COMMENTS ON PROPOSED FOOTPATH DIVERSIONS BEHIND CROWN

With reference to route descriptions and the map in document 1, 'THE NOTICE'.

This extract from the definitive map illustrates the correct numbering of the existing paths. Note the very short MT700C

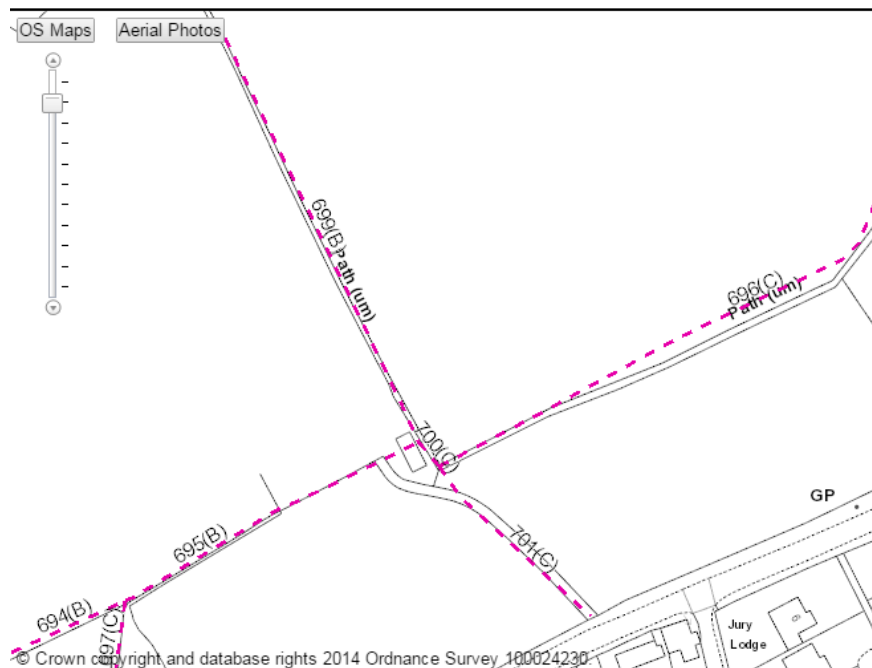
MT699B Diversion from Point A1 to C seems to be **missing from the description** in the Notice. If the diversion is to go ahead (see our notes below), this **MUST** be corrected.

MT700C As written no issues, but the map marks MT700C **incorrectly** as part of the current MT699B. Route numbering is a convenience and is not fatal to the application.

Further, the Town and Country Planning Act 1990 SI 1993 No 10, requires that routes to be diverted or stopped up should be marked in bold **BLACK** lines and the new routes in bold **BLACK** dashed lines. The map presented by MHDC has these items in **RED** and is therefore incorrect.

MT696C We can see little point in diverting MT696C through points KJIH. The direct route from K to H is direct, visible, logical and obvious and most users will follow it. For most of direct KH there is a roadside tarred pavement. We were confused as to why the contractor suggested this change and in our opinion it is not necessary.

MT699B There would have been plenty of space along the original route to the East of the hedge line if the contractor wanted the original route retained. There still is plenty of room, though it would take a little off the show house garden and possibly invade privacy the way that the layout of the house has been designed. The proposed route is to the West of the hedgerow on, we deduced, a pavement at the side of the cul-de-sac serving a couple of new homes. At the Northern end of MT699 we need assistance to understand the reason for the short diversion to the East of the existing route through CBA. Subject to our notes below and our somewhat limited understanding of the reasons behind the proposal, we believe the proposed diversion is not necessary.

Extinguish MT699 and MT700 and route the diversion around the extreme South West of the site and along the North Western boundary to point A. This route offers a much more pleasant experience to the walker, with excellent views to the West, avoids walking through housing and does not invade home owners privacy (some type of rear fencing/ hedging behind the properties would be required). Currently the temporary diversion (created without reference or permission by TW?) follows this line for approximately half its length.
